WATER PERMIT NO. 2015-1

SOUTH DAKOTA
WATER PERMIT NO. 2015-1

**RECOMMENDATION OF CHIEF ENGINEER FOR WATER PERMIT
APPLICATION NO. 2015-1, Two Bit Ranch Estates Homeowners Association Inc.**

Report to the Chief Engineer
On Water Permit Application No. 2015-1
Two Bit Ranch Estates Homeowners Association Inc.

LAWRENCE COUNTY
SOUTH DAKOTA

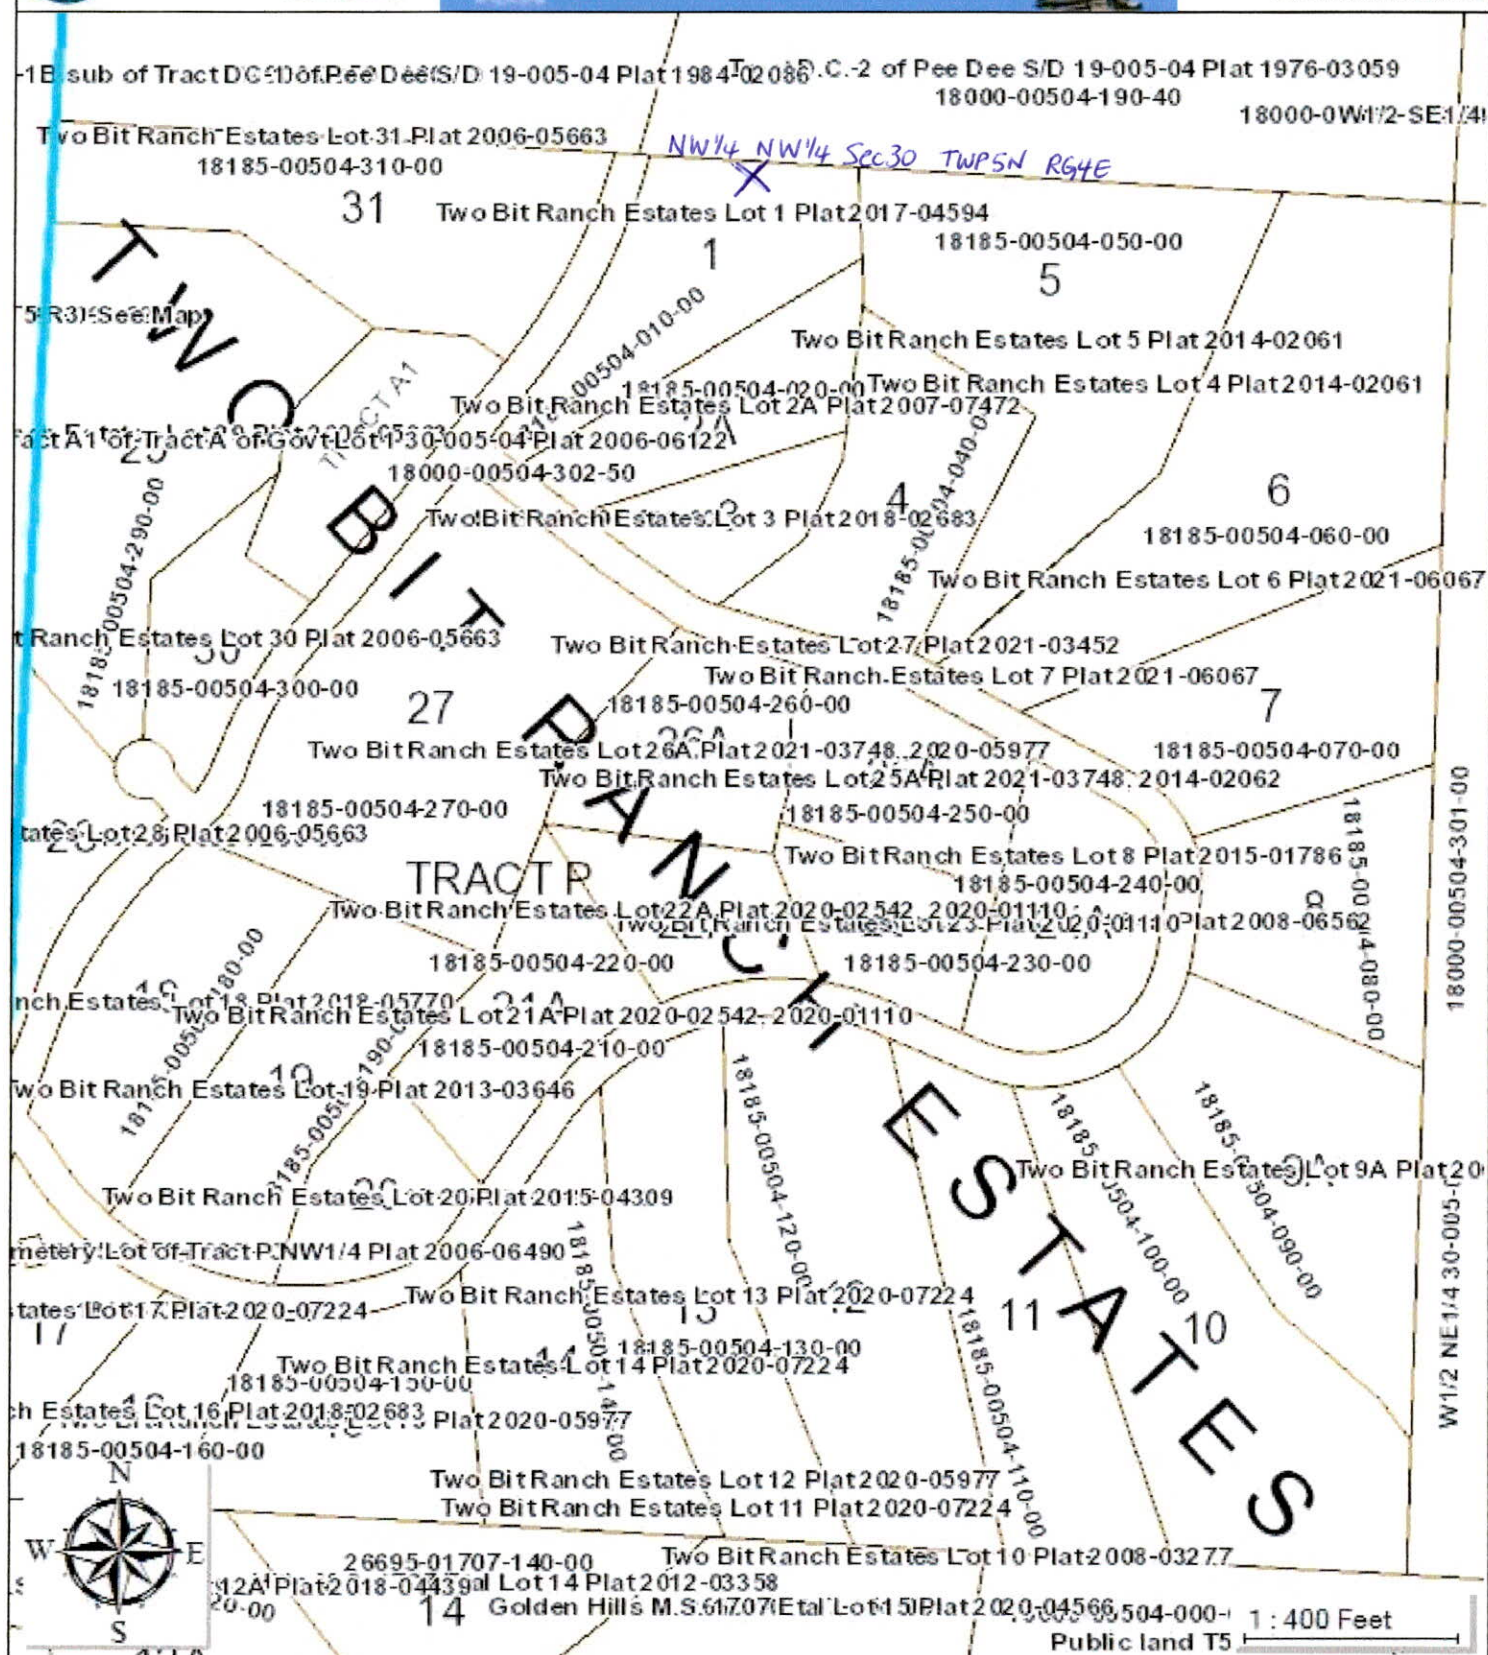
- Enclosed is an aerial imagery map showing the approximate location of the existing well based on the plat map submitted with the application. Please confirm that the well is located in the correct location.

- The location where the water will be used also needs to be identified on the application. For example, if the entire area being served is encompassed by the NW1/4 section 30-T5N-R4E, then that area needs to be identified on the application (item No. 4 on application, copy enclosed). If anywhere else is being served that area needs to be identified also.

Regarding Point #1: The white dot you can see on the aerial map is the pumphouse. The wellhead is to the right of the pumphouse on this map. I've enclosed a copy of the map and an X has been placed there.

Regarding Point #2: I've checked the Lawrence Co. GIS website and it shows that all of the Two Bit Ranch Estates properties are listed to be in Section 30 - Township 5N - Range 4E. No other properties will be served by this well.

Regarding Point #3: The HOA is not aware of any other domestic wells nearby. There is an abandoned well on Lot #27. I've noted the approximate location with an X on the enclosed copy of the aerial map.
